Addendum #1

Date: November 19, 2021
Project: **Offsite Waterline Supply**
Lukachukai Community School Replacement
Location: Indian Route 12
Lukachukai, AZ 86507

RE: LCS & NHA Offsite Waterline, Lukachukai AZ – NTUA-HQ Review @ 'Pre-Final' Submittal

C-06 ✓ OF

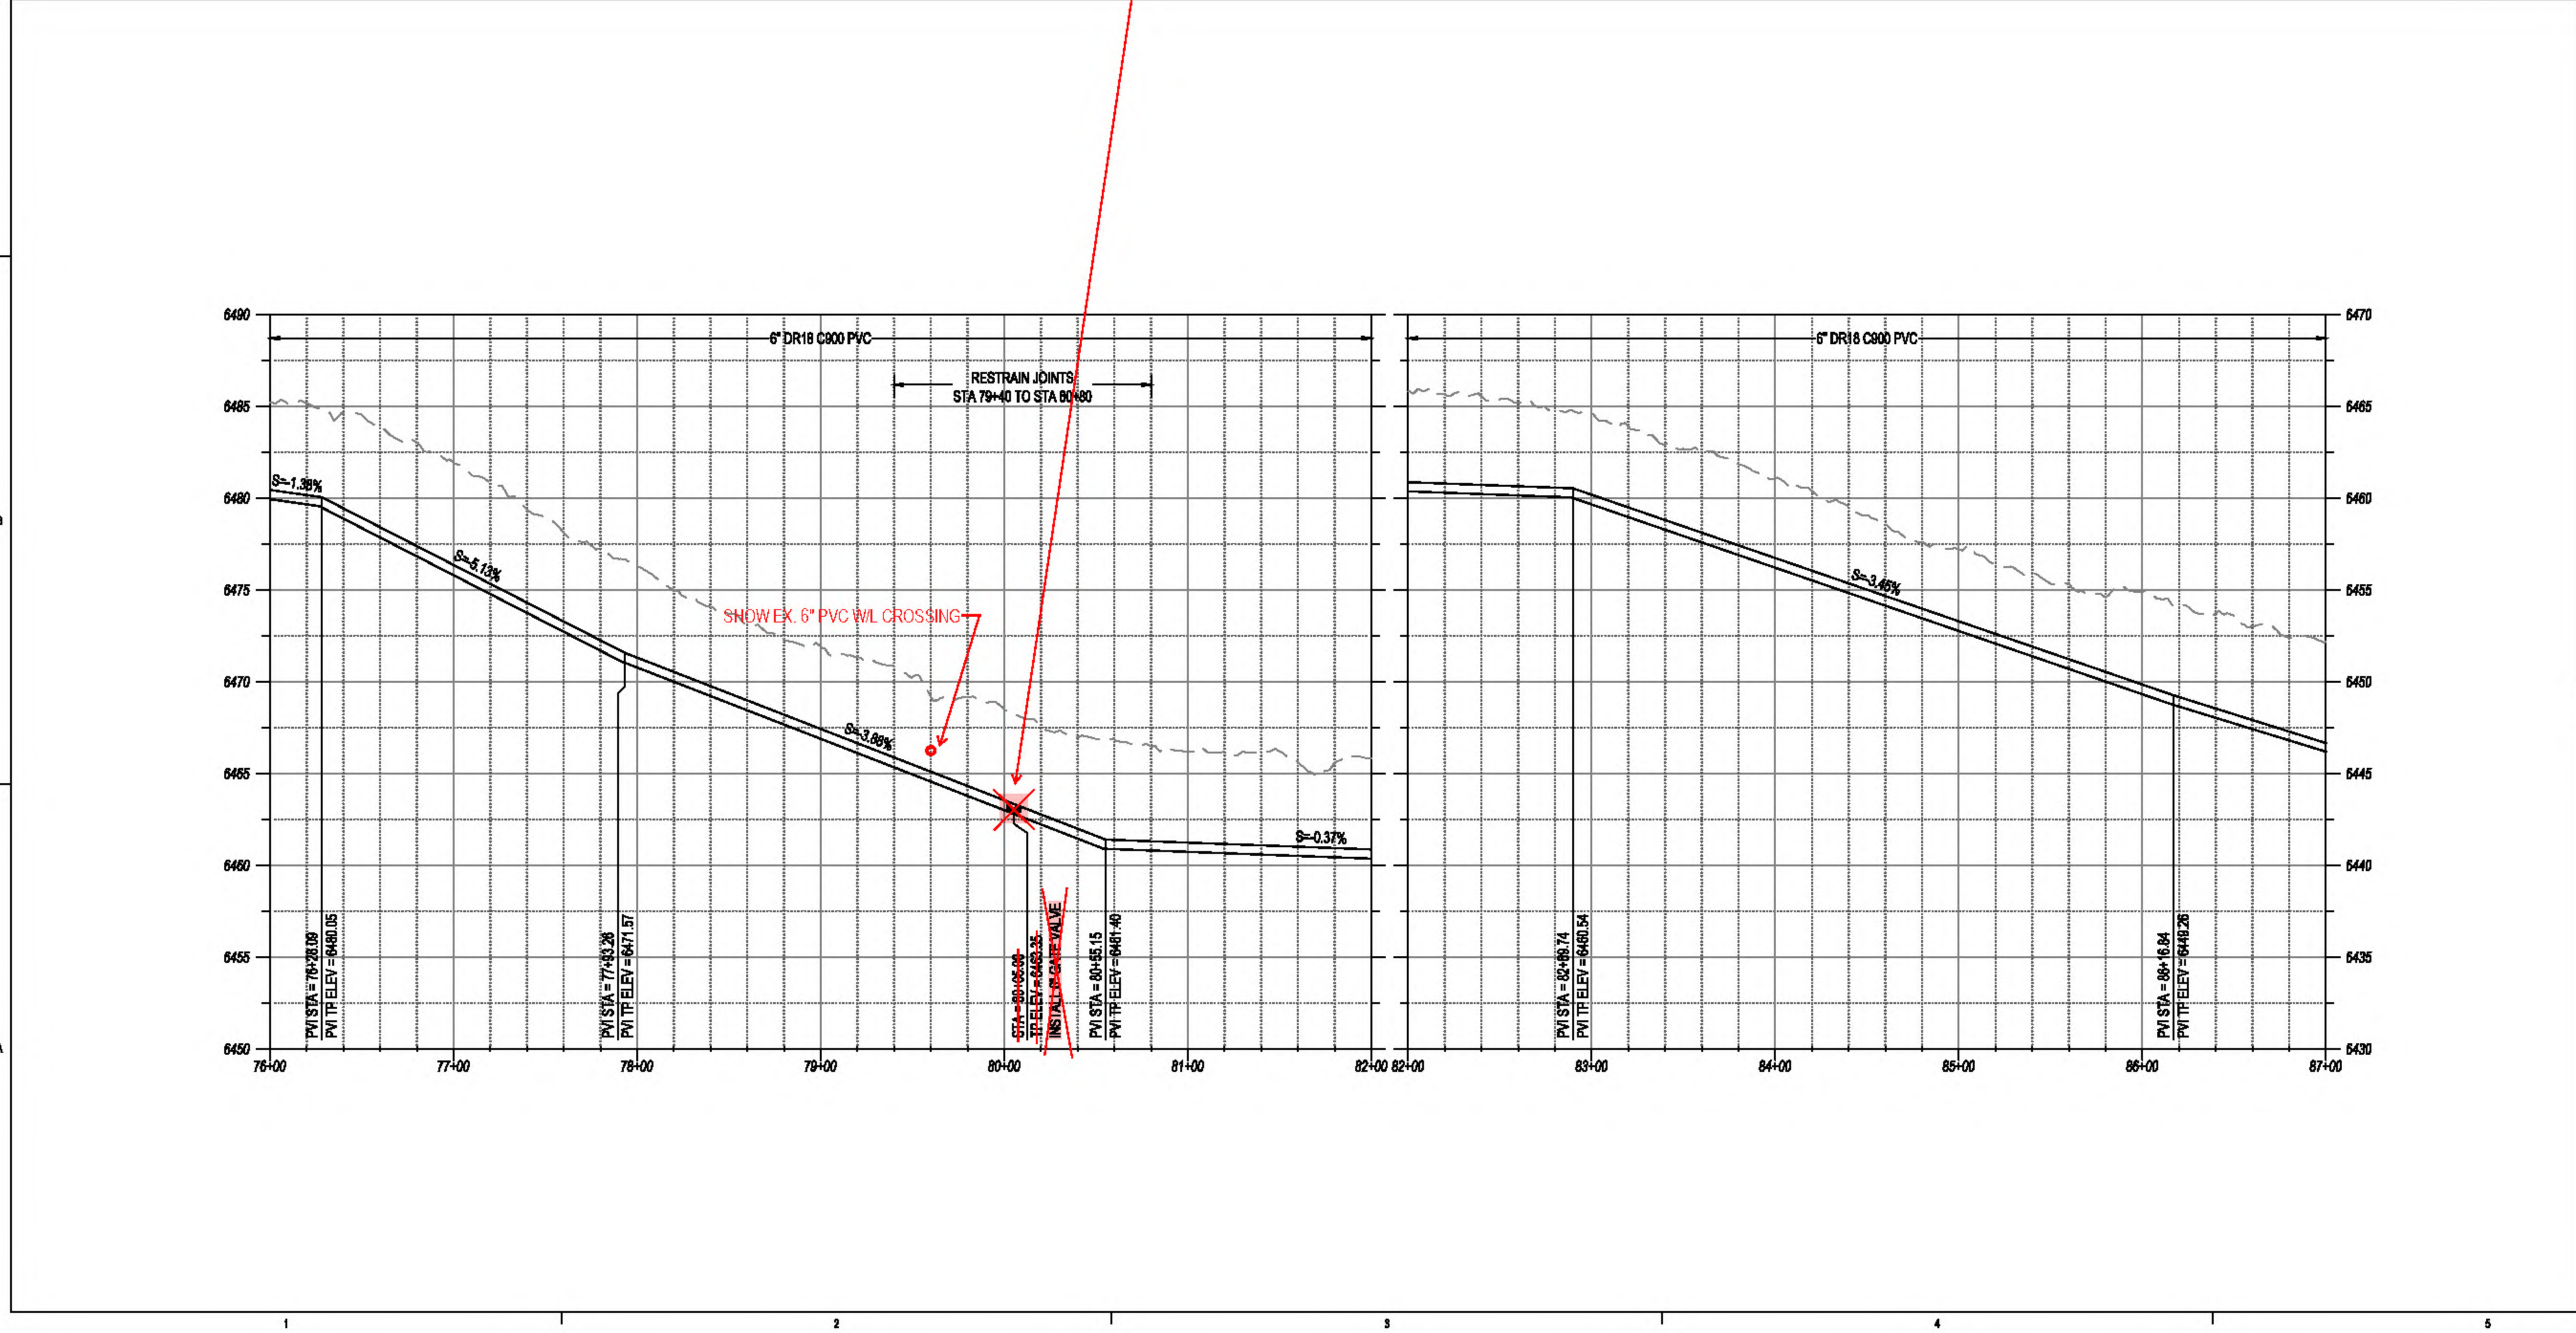
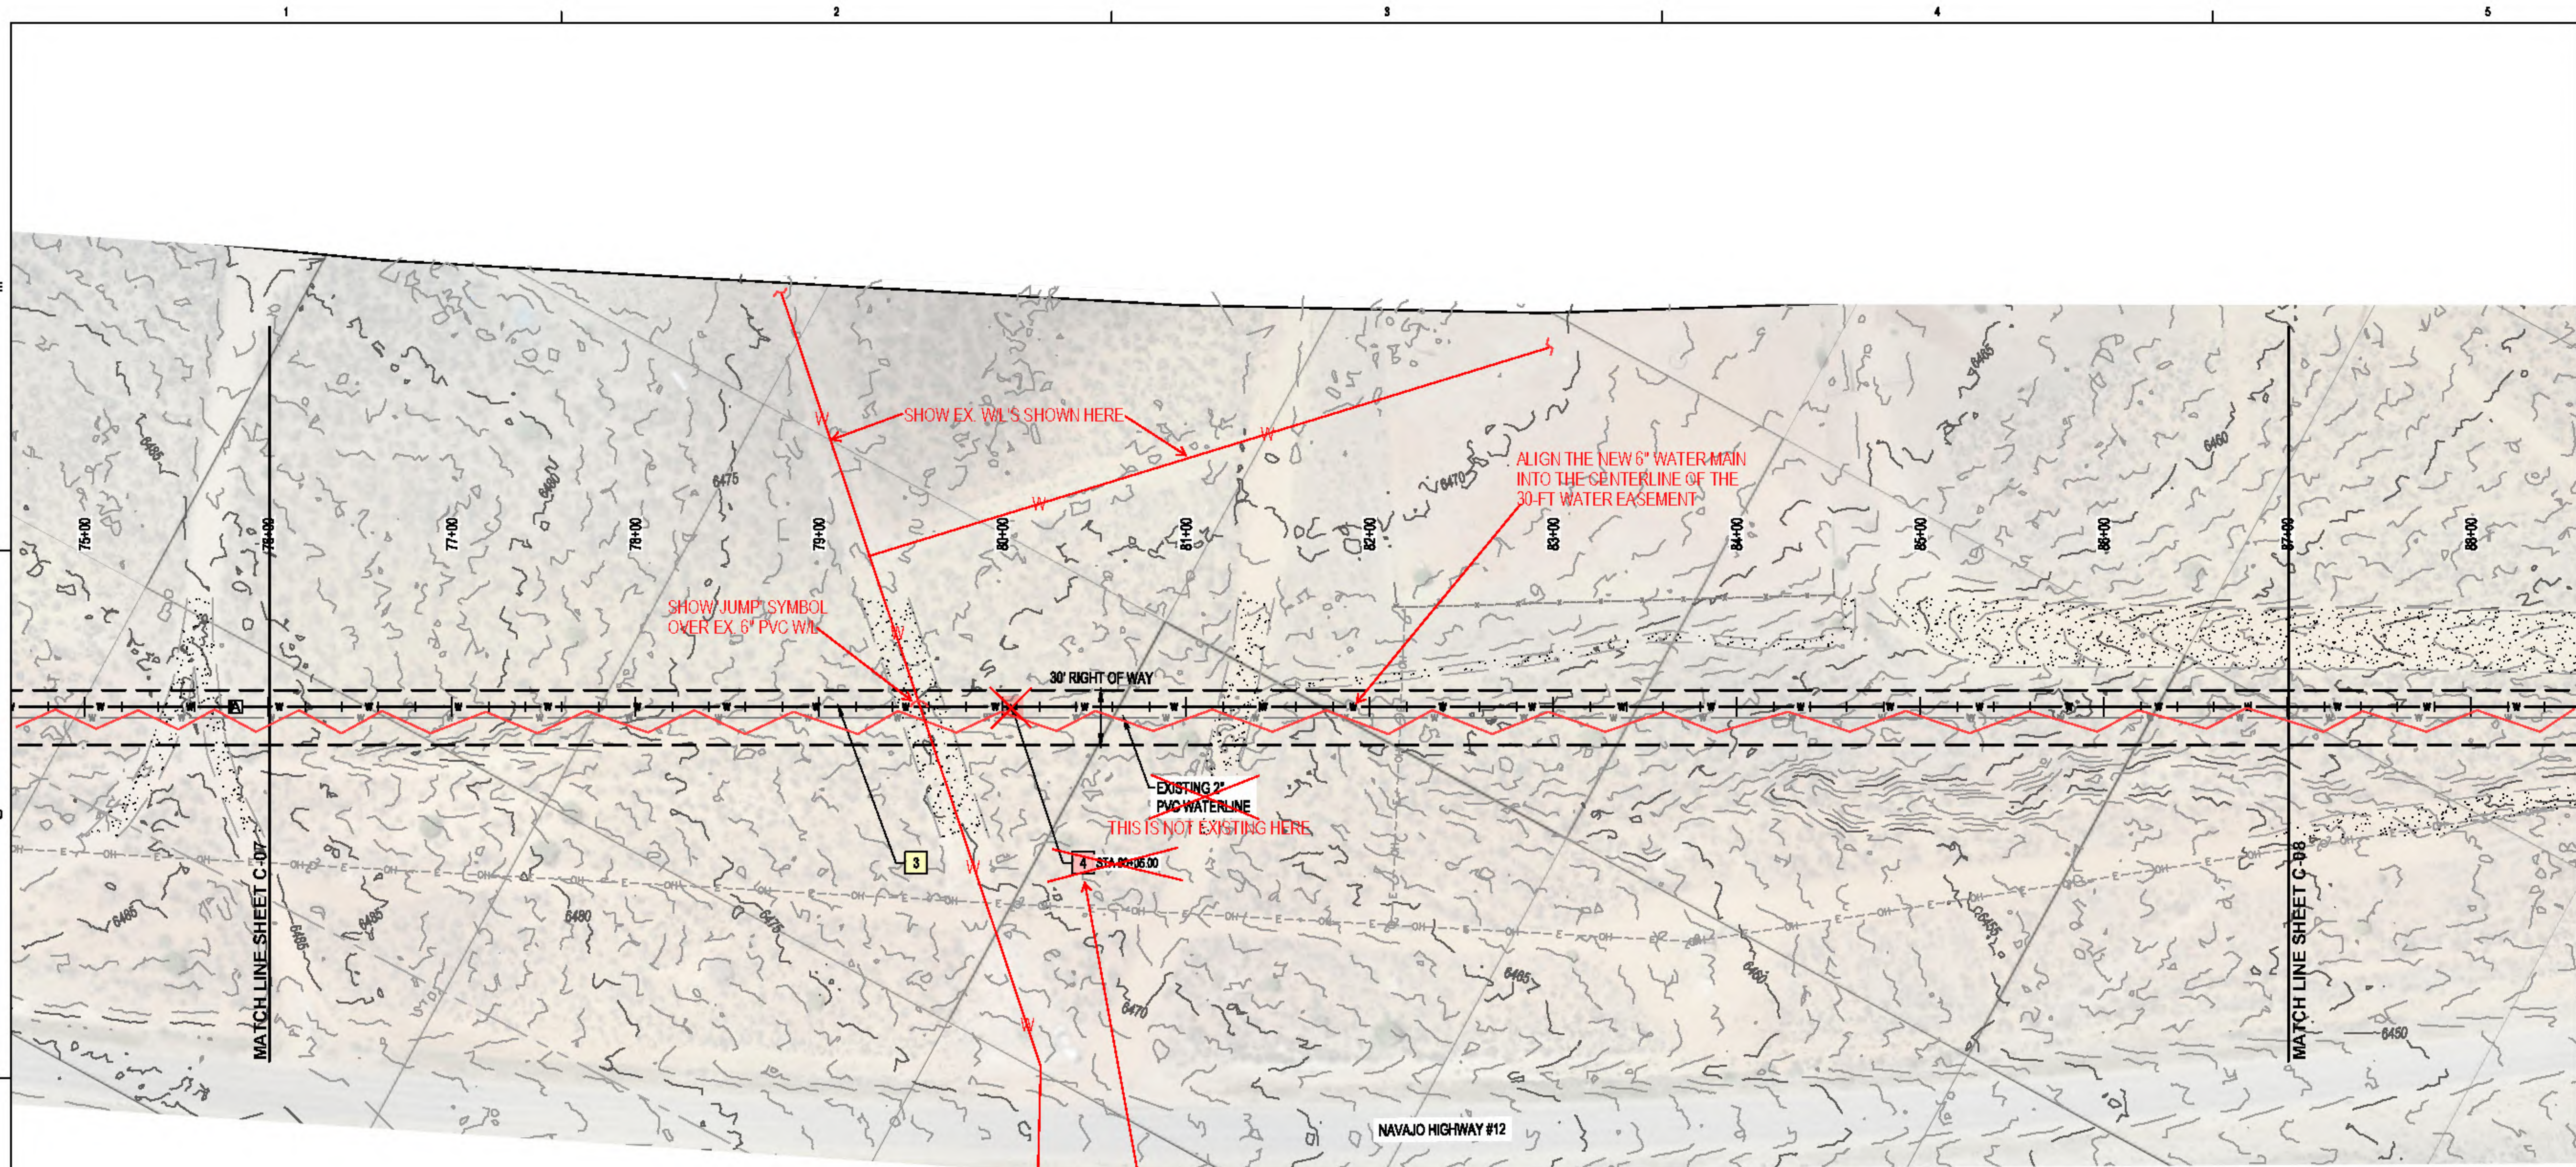
1. Non-existing 2" PVC W/L: Delete/erase the shown ex. 2" waterline alignment that is shown from Sta. 65+00 to Sta. 76+00, which are the matchlines for this sheet. This does not exist in the field.

2. New 6" PVC C900 W/L alignment: From Sta. 65+00 to Sta. 76+00 (matchlines for this sheet), align the new 6" water main at the centerline of the new 30-ft water easement/ROW.

2. General Comment: Show the highway right-of-way lines on each plan sheet (typ).
3. Show the requested 100-ft expanded road crossing for boring operations. Coordinate this expanded crossing permit w/ the BIA Chinle Agency DOT.

4. Show and callout the planned steel casing from highway ROW-to-ROW as shown.
5. Planned Gate Valves at End-of-Casing locations: Move/revise the road crossing gate valve locations to 3-ft min. outside highway ROW lines, as shown.

6. Plan Keyed Notes #14 (Bore Pit): On the plan, show/label the bore pit descriptions on the keyed note (Launch Pit/Receiving Pit) as shown.
7. Sta. 70+05.00 (Proposed 6" in-line Gate Valve): Move/revise this gate valve to 3-ft downstream of the second 45° degree bend at/near Sta. 69+14.09 (+/-).

1. Planned fitting symbols: Show/label the bend symbols in the profile, as shown.

C-07 OF

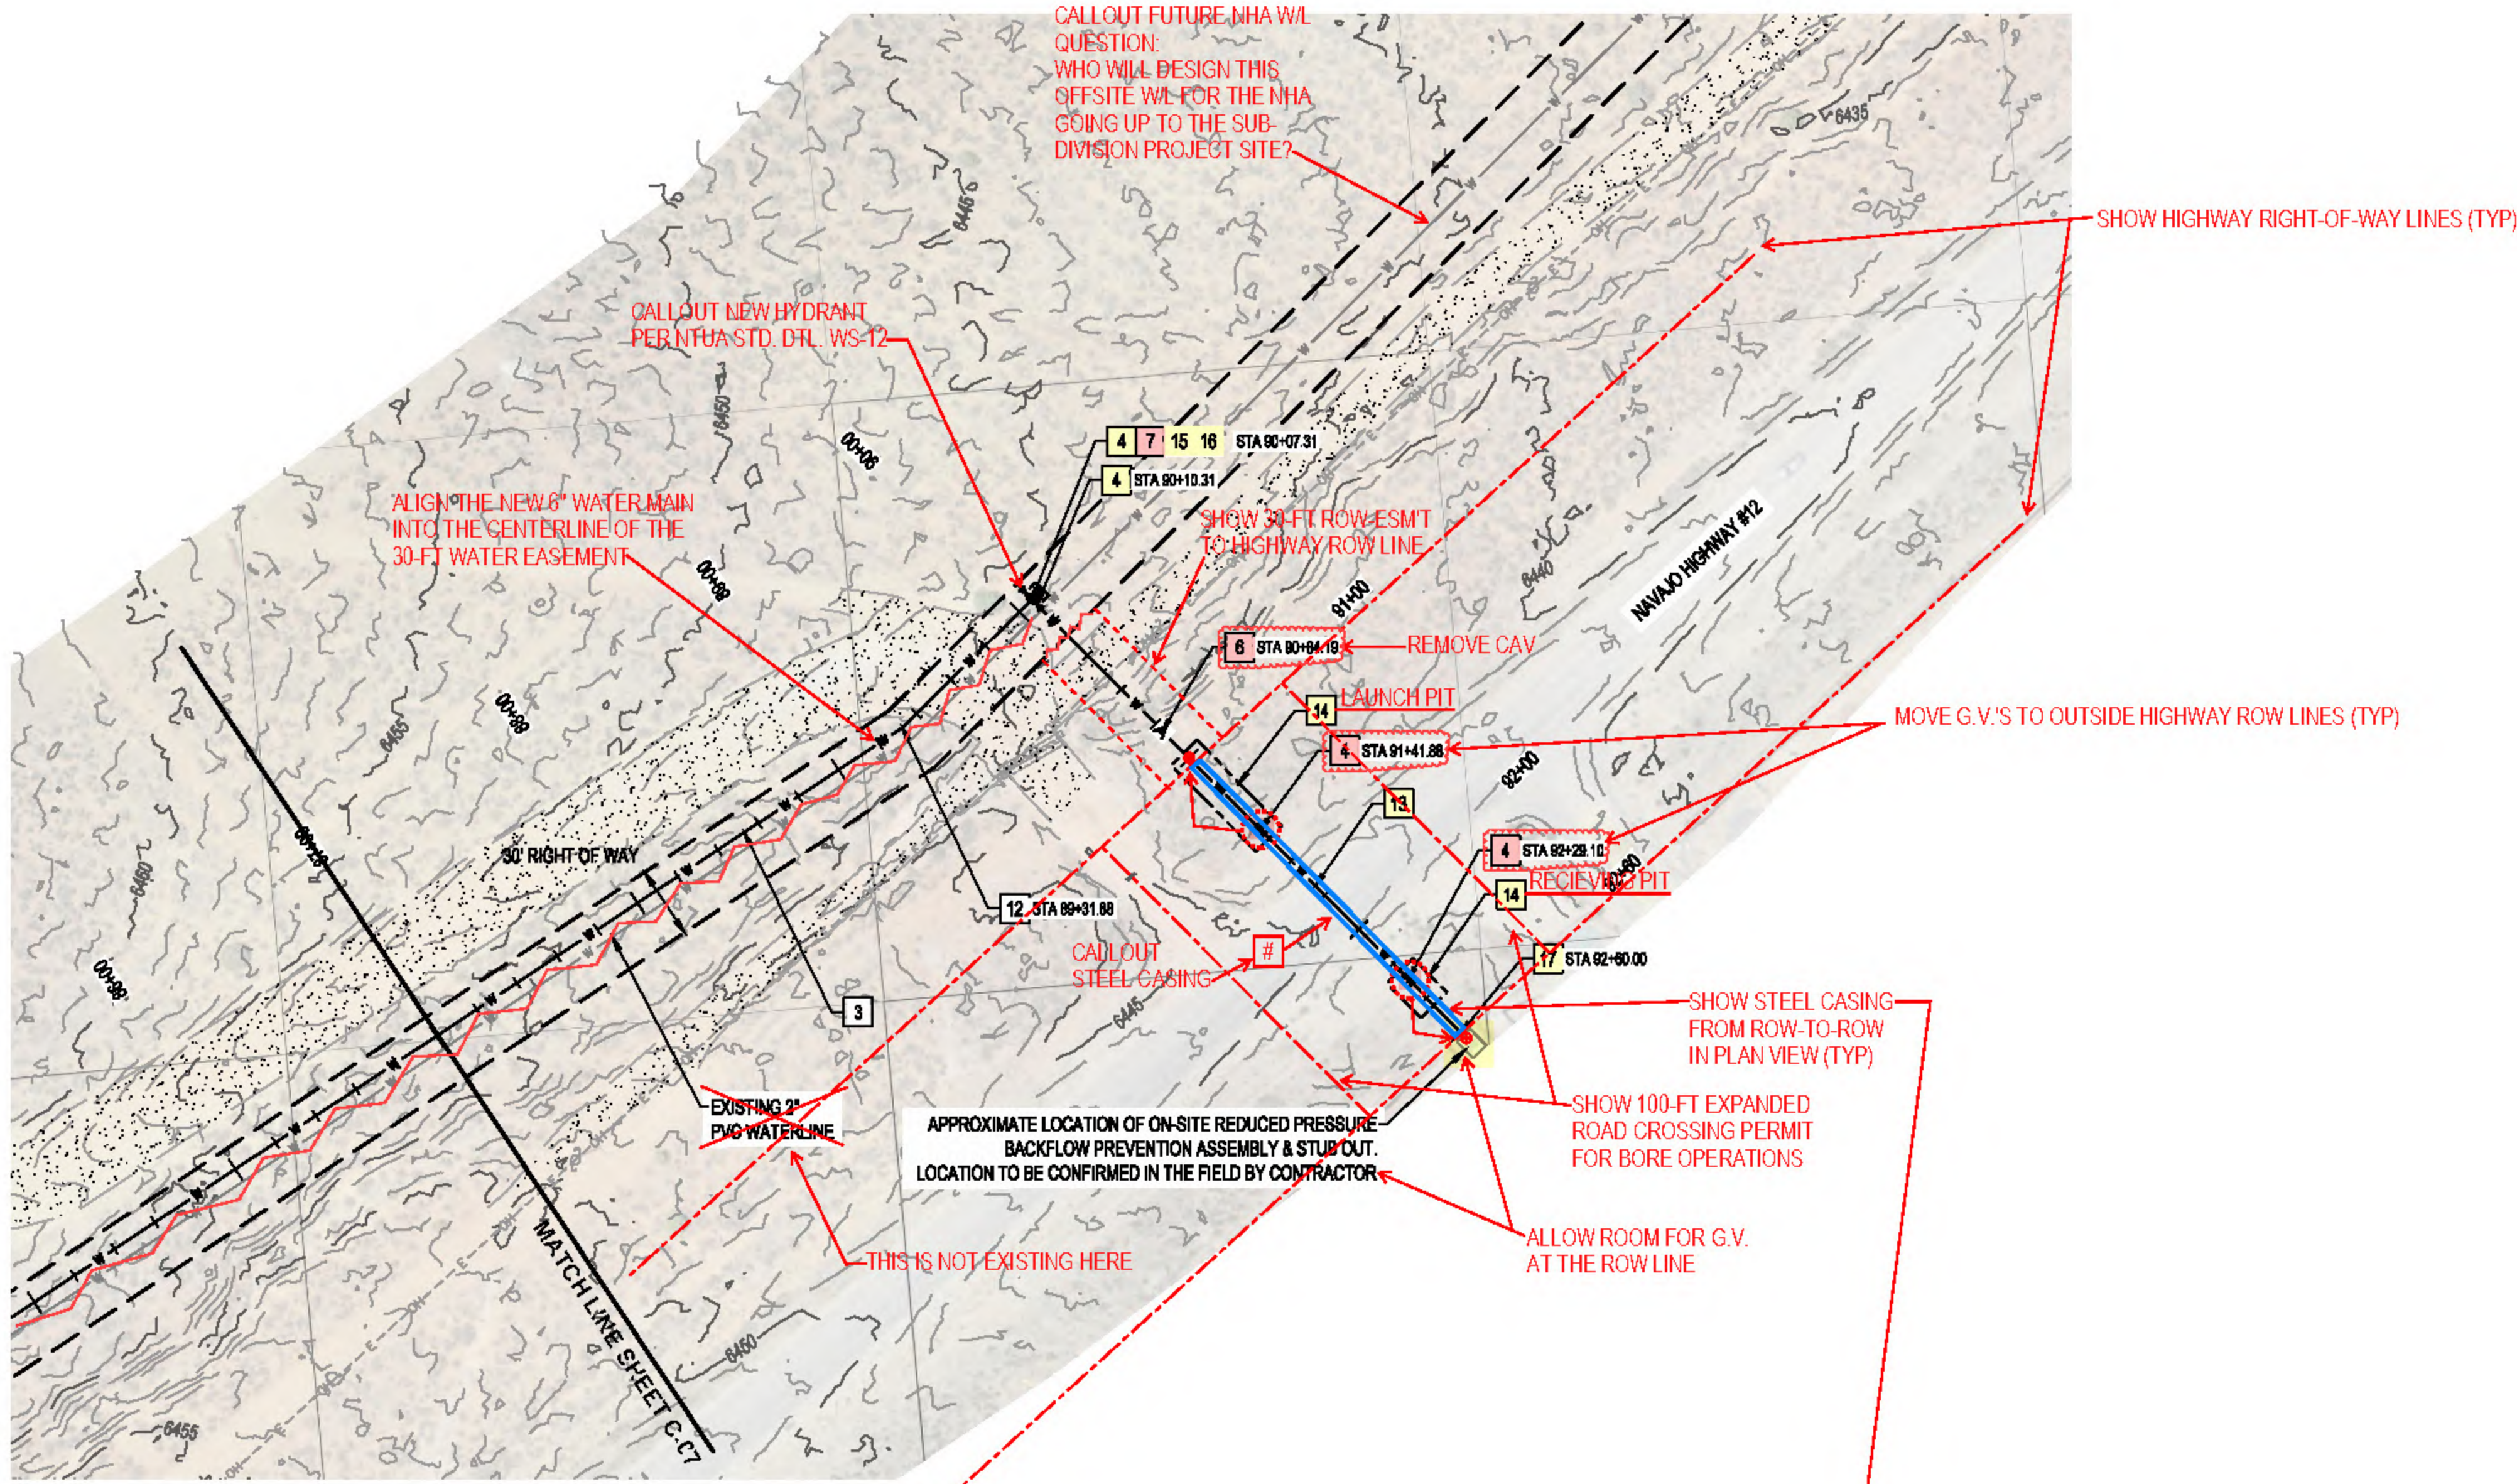
1. Non-existing 2" PVC W/L: Delete/erase the shown ex. 2" waterline alignment that is shown from Sta. 76+00 to Sta. 87+00, which are the matchlines for this sheet. This does not exist in the field.
2. New 6" PVC C900 W/L alignment: From Sta. 76+00 to Sta. 87+00 (matchlines for this sheet), align the new 6" water main at the centerline of the new 30-ft water easement/ROW.
3. General Comment: Show the highway right-of-way lines on each plan sheet (typ).
4. Ex. Waterlines not-shown: Show and label the ex. waterlines that exist in the field as shown on the plan sheet.
5. Sta. 80+05.00 (Proposed in-line 6" Gate Valve): Remove this proposed G.V. as it will not be required at this location.

1. Ex. 6" waterline crossing: Show/label the ex. waterline in the profile, as shown.
